| Project | IEEE 802.16 Broadband Wireless Access Working Group < http://ieee802.org/16 > |
| Title | Amendment to EAP Security Primitives in 14.2.2.1 |
| Re: | Contribution on comments to IEEE 802.16g/D8 |
| Abstract | Re-definition of EAP primitives in 14.2.2.1 |

Figure 473 – EAP based Authentication Procedure

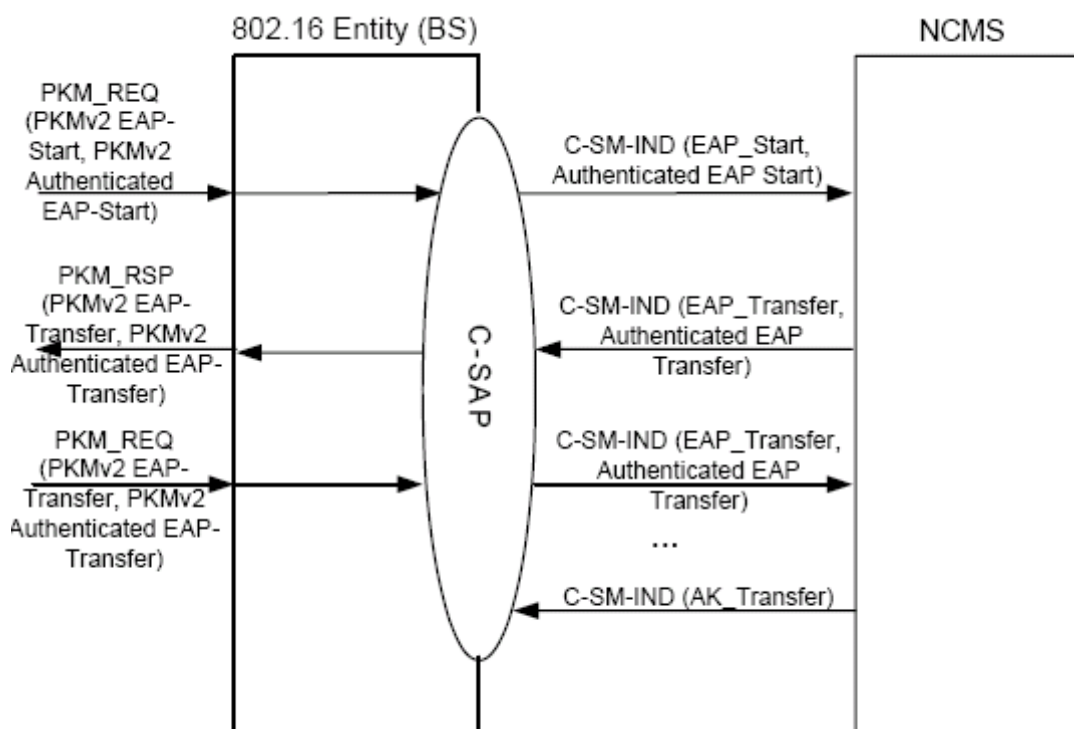
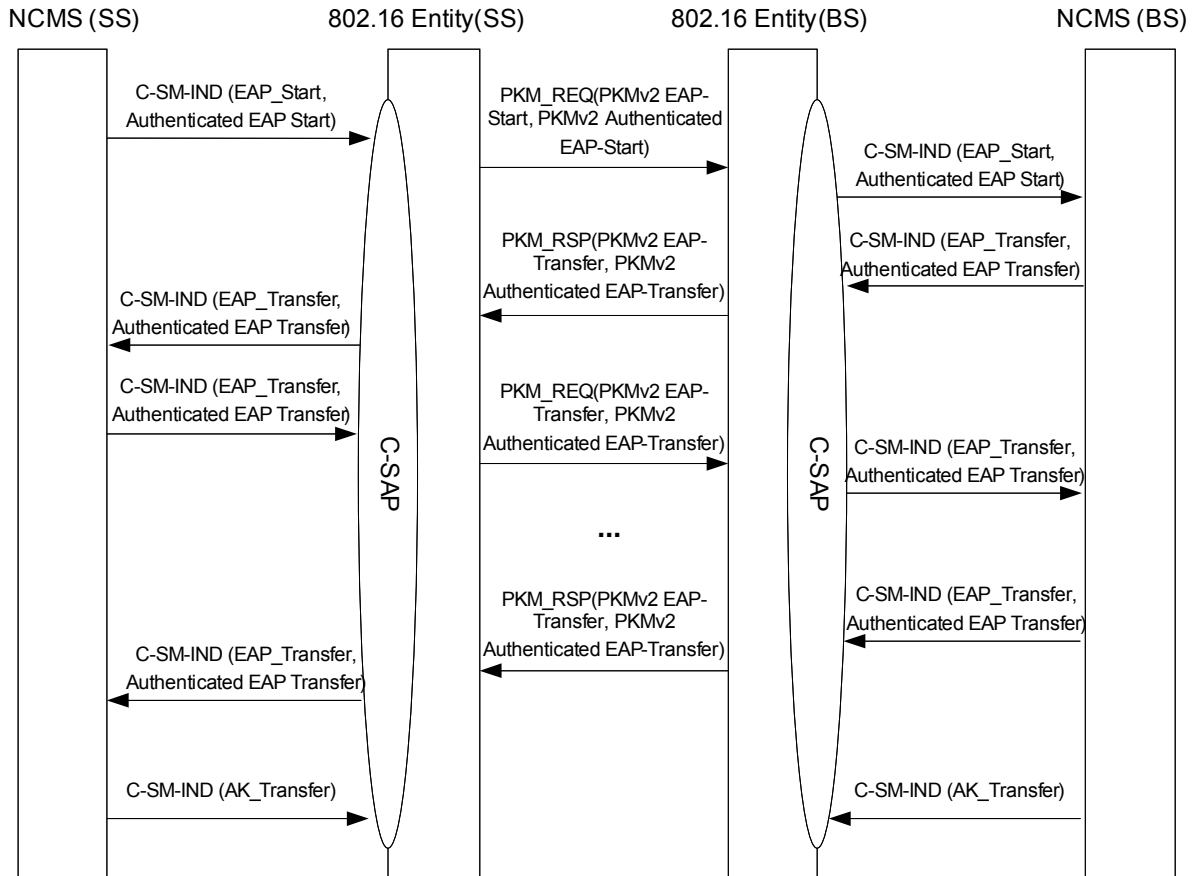
1. Modification of figure 473 to illustrate EAP-based security primitives on SS side.
2. Modification of each subsection to clarify and describe on each side (SS and BS side)

Figure 473 shows EAP-based authentication procedures between an BS-802.16 entity and an NCMS on SS and BS sides and an AAA Services entity in NCMS as follows:
